Additions and Renovations
Platt Technical High School
Milford, CT

ADDENDUM NO. 3

August 2, 2019

1 CURTAIN WALL TYPES
1/4" = 1'-0"

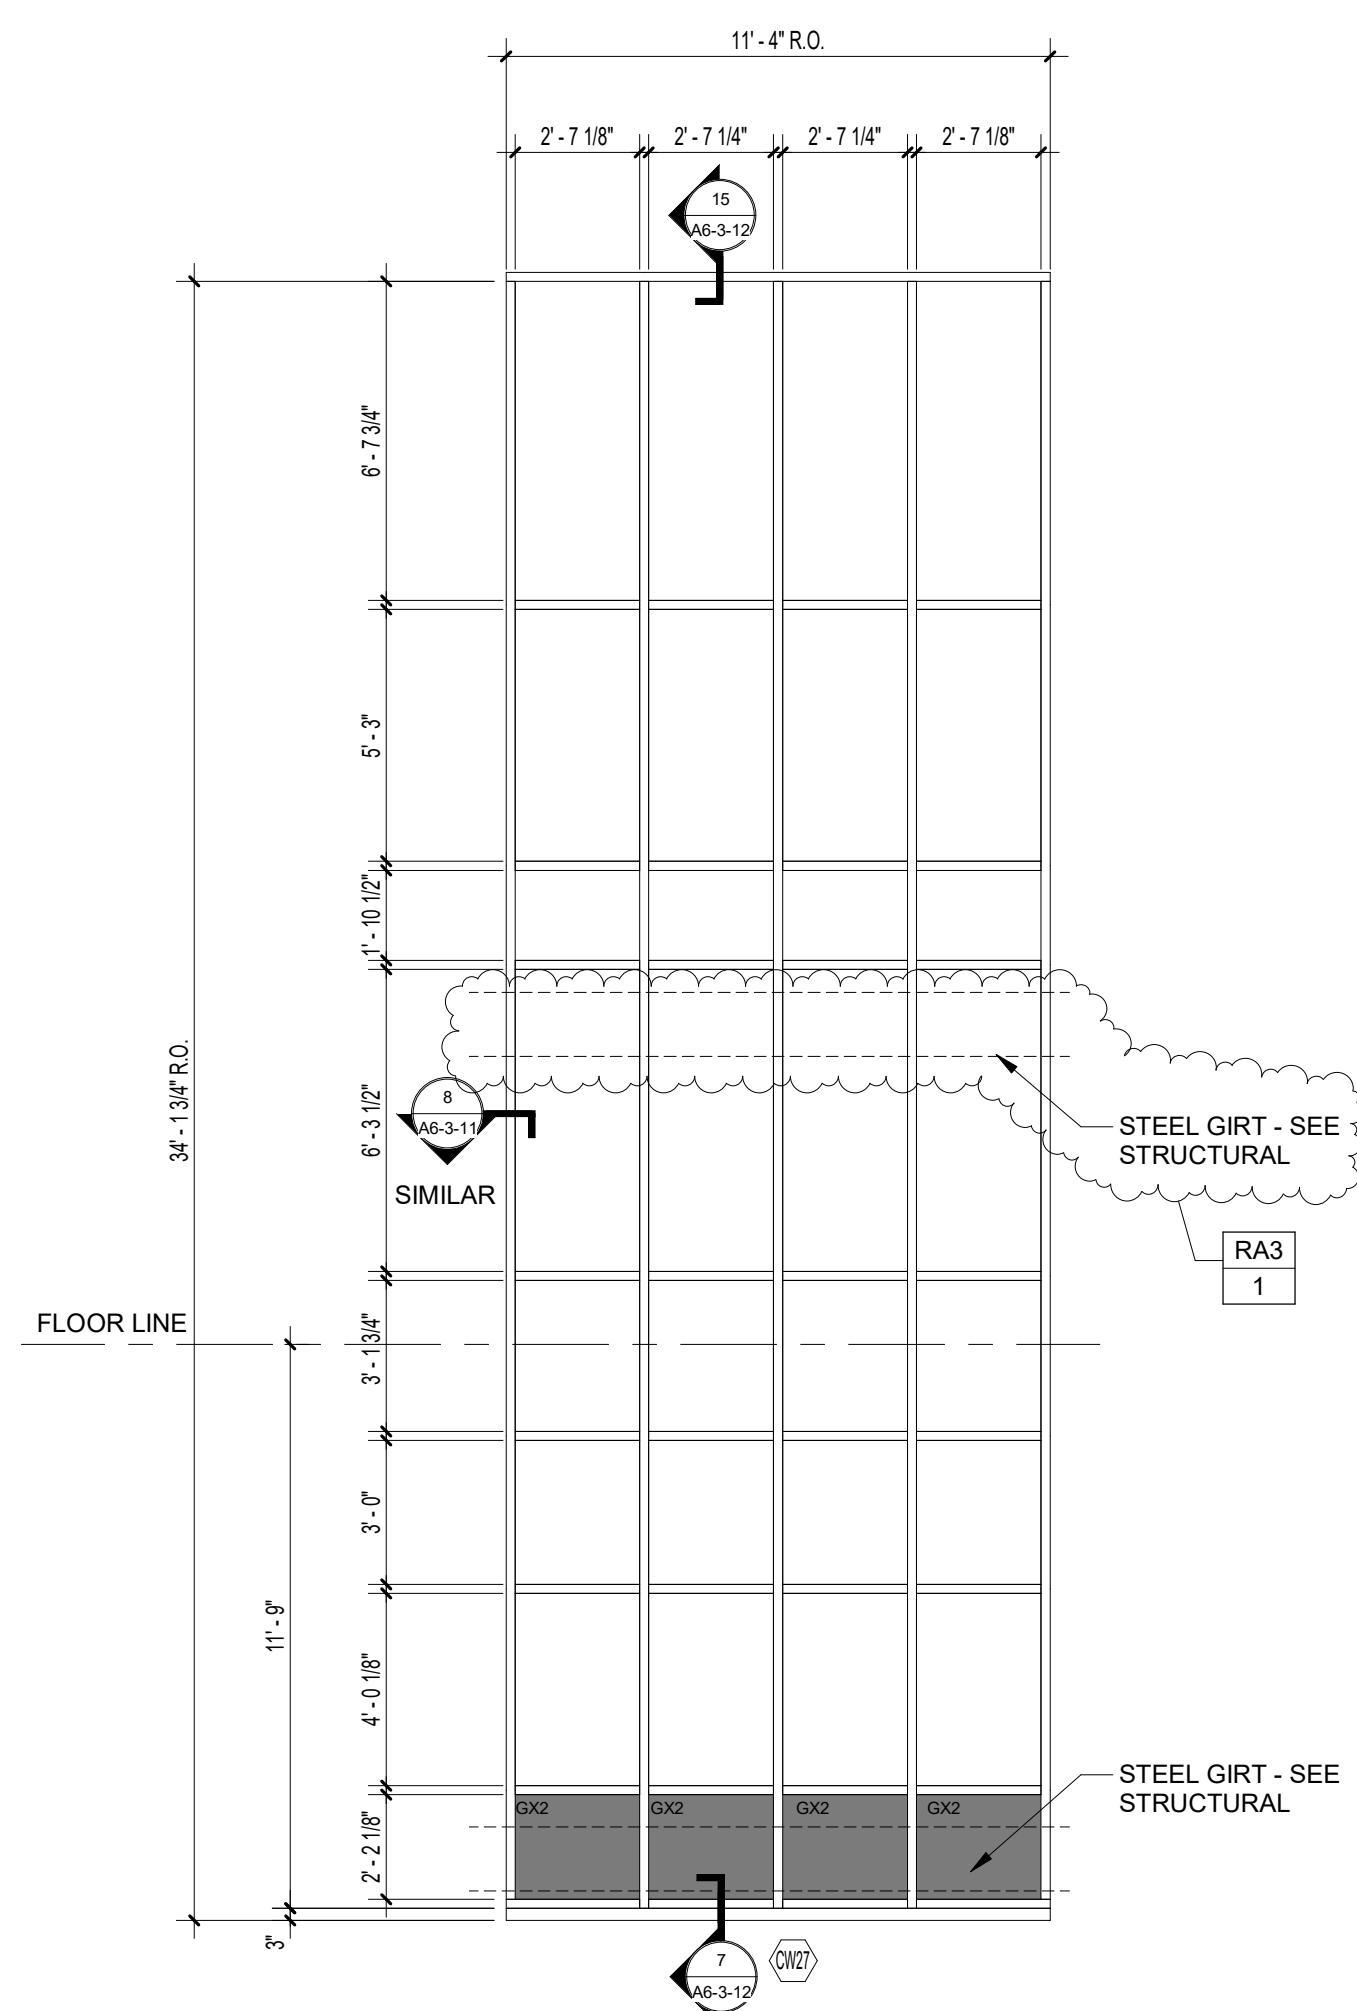
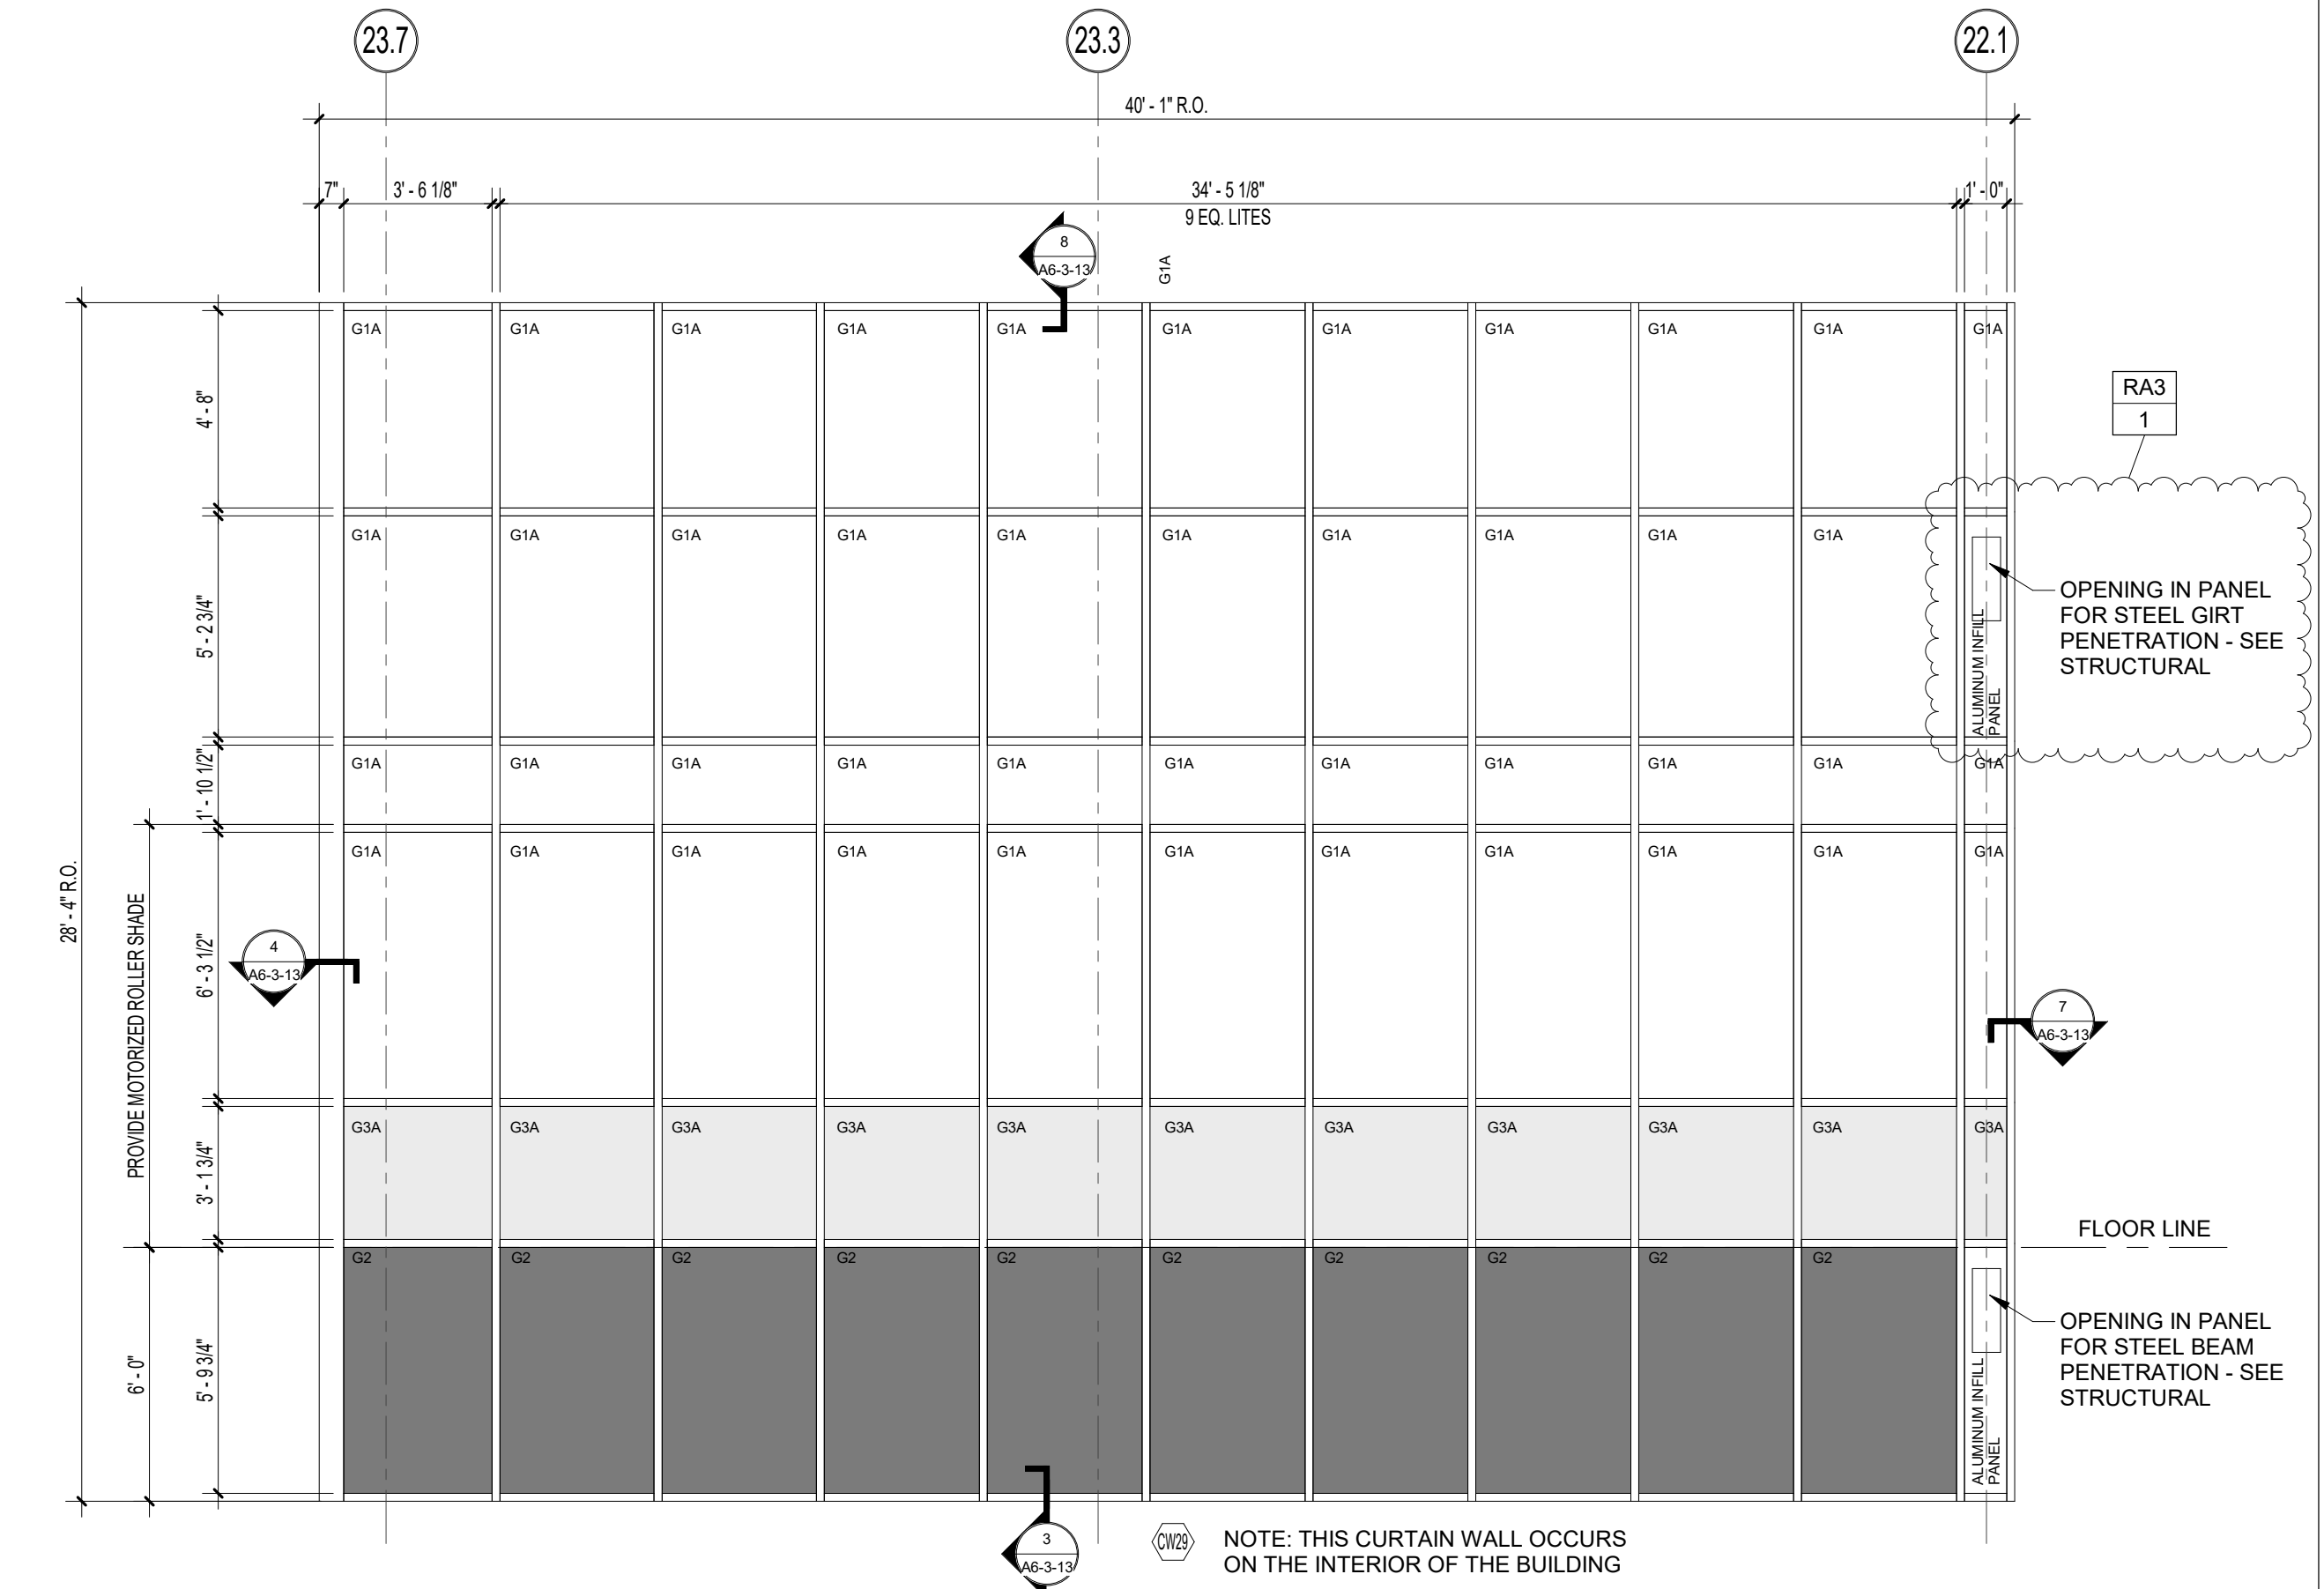
- ADD 3-062 DRAWING A2-2-3 – DOOR, FRAME AND BORROWED LIGHT TYPES**
Revised dimensions of door Types AL1 & AL2 per Sketch RA3-09.
- ADD 3-063 DRAWING A6-3-4 – CURTAIN WALL AND STOREFRONT TYPES**
Revision RA3-1:
Frame Type SF5: Revised detail tag.
Frame Type CW27: Added steel girt note.
Frame Type CW29: Added note for opening in panel.
Frame Type CW35 (*previously SF3*): Revised frame type.
